Planning Approval Consistency Assessment Form

Assessment Name:	Five Dock Single Cavern
Prepared by:	AFJV Environment Manager
Prepared for:	Sydney Metro
Assessment number:	AFJV01
Status:	Final
Version:	1.0
Planning approval:	CSSI 10038 Sydney Metro West Concept and Stage 1
Date required:	August 2021
iCentral number	SM-21-00280381

Five Dock Station – single cavern design

21028-NV-CR-1-2

Figure 1 Indicative binocular (EIS design), top, and indicative single cavern (Alternative design), bottom

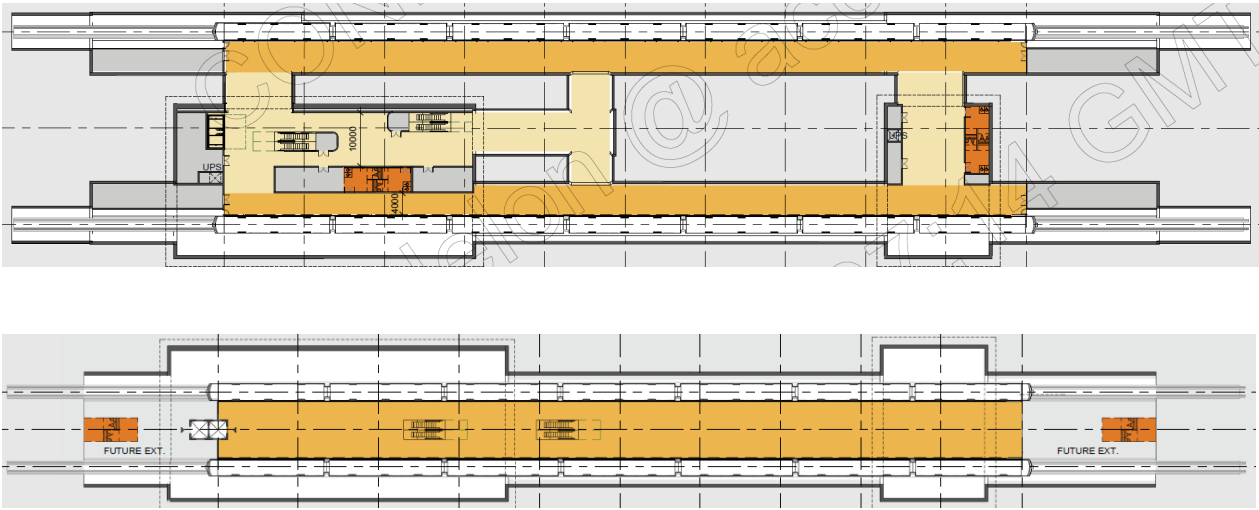
During detailed design, AFJV has identified an alternative design for the Five Dock Metro Station than was described in the Environmental Impact Statement for the Concept and Stage 1 of the Sydney Metro West project between Westmead and The Bays (the EIS) (the Alternative design).

The Alternative design involves construction of a single cavern structure rather than a binocular design (EIS design). The indicative binocular and single cavern designs are illustrated in Figure 1.

The Alternative design would retain the footprint of the proposed station box but would bring the Up line (RT02) within the station, a horizontal adjustment of approximately 22 metres. The Down line (RT01) would remain in its current position. No change to the vertical alignment change is anticipated.

The Alternative design would also result in a proportional change to the Up track horizontal alignment, as illustrated in Figure 2.
